Urban Design Review Panel Submission
New Embassy and Consulate of the State of Qatar
187 Boteler Street, Ottawa

Formal Review
Meeting date: Friday April 1, 2022

RESPONSE TO CITY URBAN DESIGN & PLANNING STAFF

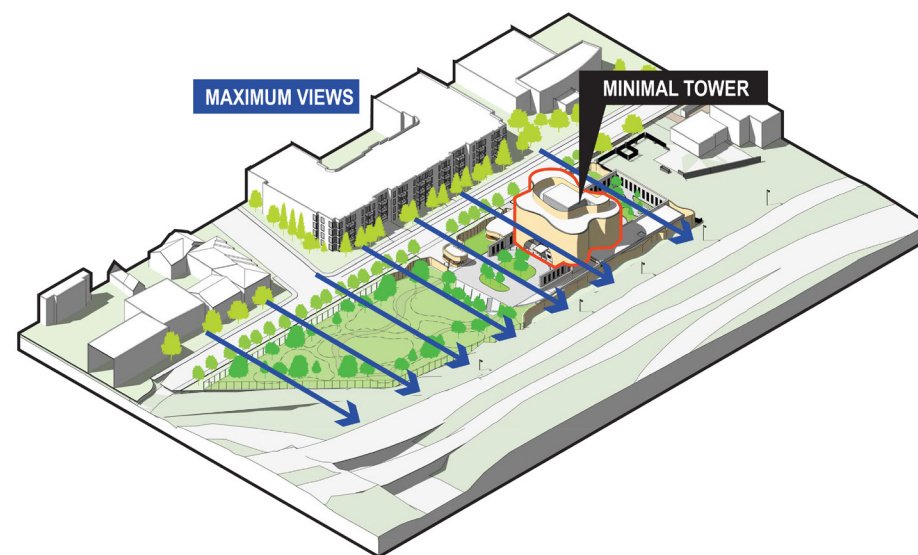
- Has the design team considered what the site looks like at night? Have you considered a lighting scheme or the potential impacts? Look at the guidelines for this area, including the NCC's illumination plan.

The lighting design will be developed in conjunction with the NCC's illumination guidelines. The curved decorative screen will be backlit in a subtle way to add shadow and depth to the facade element.

Street Section - Diagram

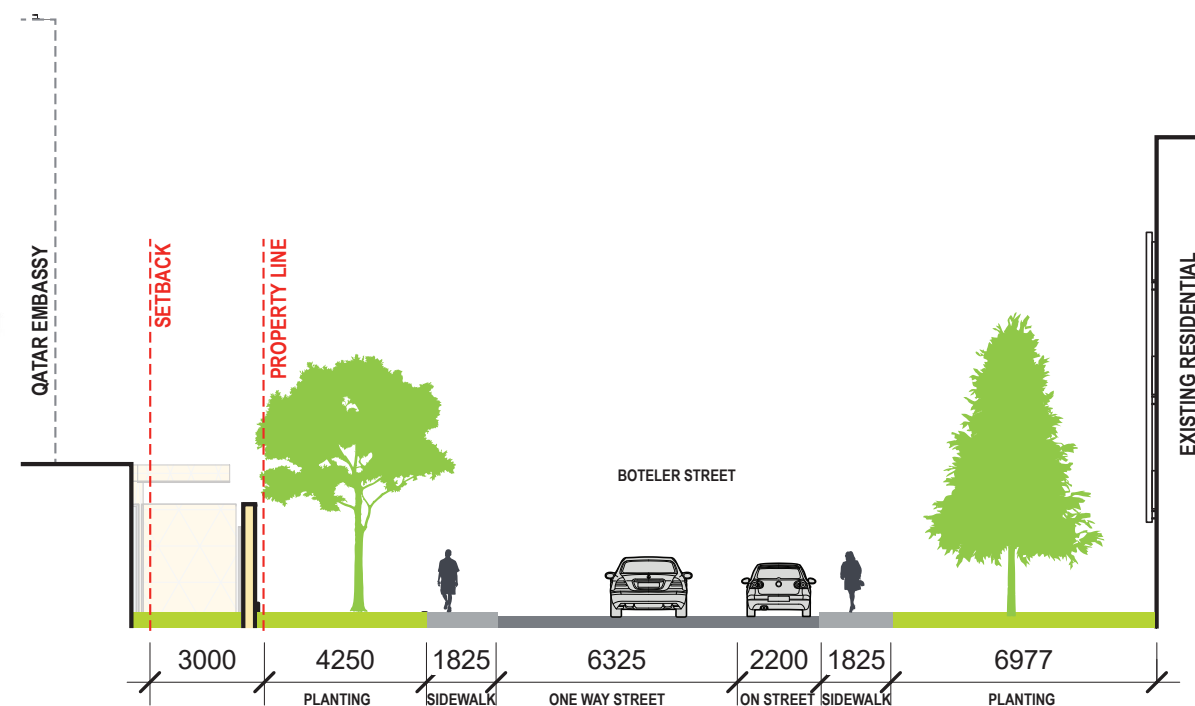
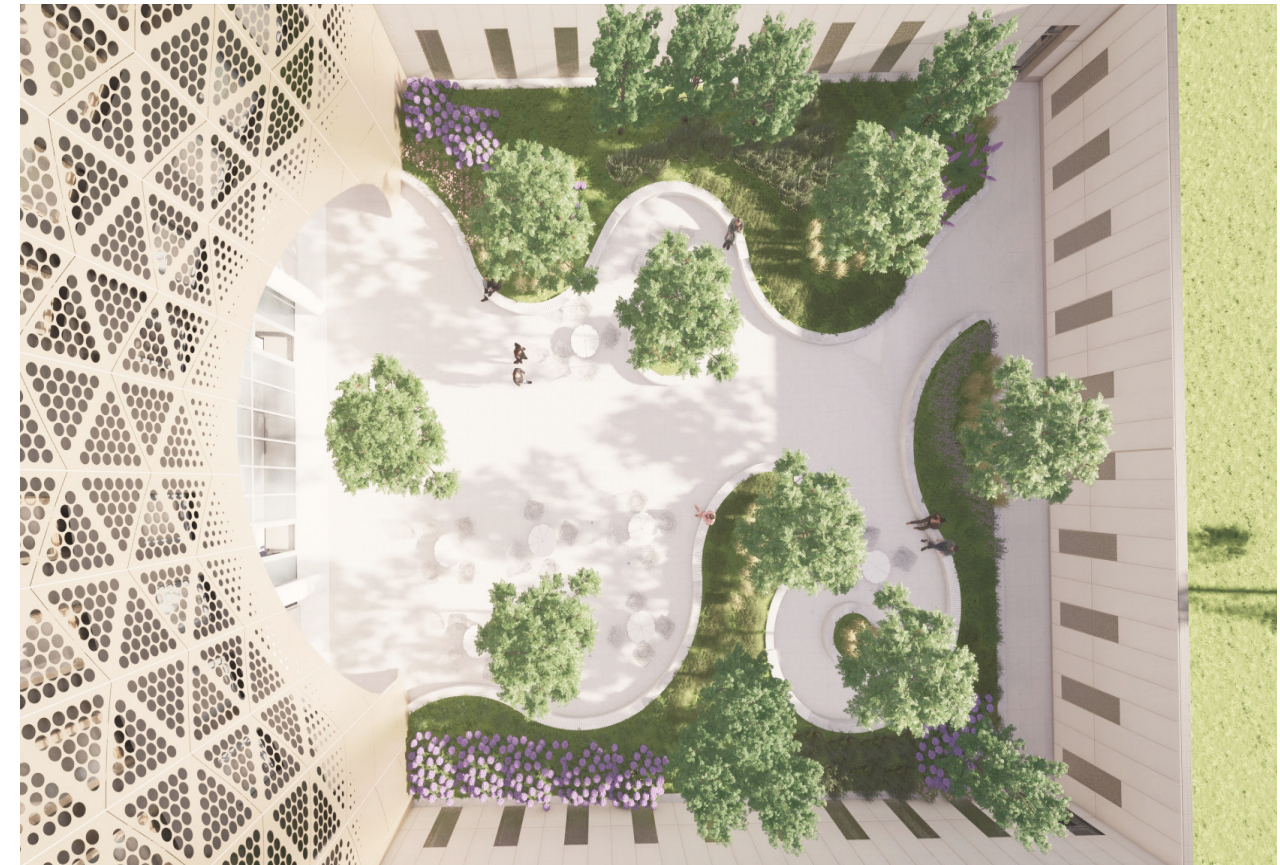
- Suggests including the surrounding context into their design.
- Very close to the road, strong face-to-face relationship
 - The condominiums are close, need to consider the relationship between the 4-storey condominiums and this development
 - Show it from the street from a pedestrian view.
- Need to be sensitive to the community they're building in
- Trees used to protect views from street to the north
- The building shows more of a hardscape from the front in the public boulevard, which is not in keeping with the abutting condition on the north side of Boteler.
- Reconsider the curb-boulevard relationship.
- What to do between sidewalk and fence line.
- Precedent: Condominium has done coniferous planting.

- Need continuation of the sidewalk on Boteler as part of the site plan drawings.

Please see renderings and diagrams to see how the comments above have been addressed. The cross-section through Boteler street shows the trees along the property line on both sides of Boteler, with grassed area abutting street. The relationship and scale of the new Embassy and condominium development to the south are illustrated.
